# Exhibit 4

Issue Number:	<b>N172404</b>	PDF Date Submitted	01/07/2005		
<input checked="" type="checkbox"/> Part - Location:	<b>Ignition Key Cylinder Assembly -Column - Steering</b>				
<input checked="" type="checkbox"/> Complaint:	<b>vehicle can be keyed off with knee while driving</b>				
Issue Type:	<b>Current Prod</b>	Vehicle/Product Line:	<b>3Acar</b>		Region:
<input checked="" type="checkbox"/> Severity:	<b>3</b>	Primary Metric/Score:	<b>LaunchX / 0.025</b>

## GMX001 Lock Module Detent in RUN

### *Containment Solution*

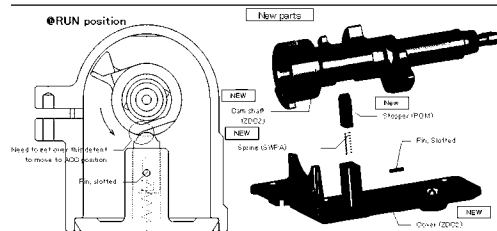
➤ Changing slot in the key in order to reduce lever arm and thus the torque:

✓ It was determined that the lever arm is still present due to fob ring. This may even cause a higher pulling load if fob ring is wedged between the slot and the sharp corner of key.

✓ Can be considered as a containment if the shape of key is changed to round corners
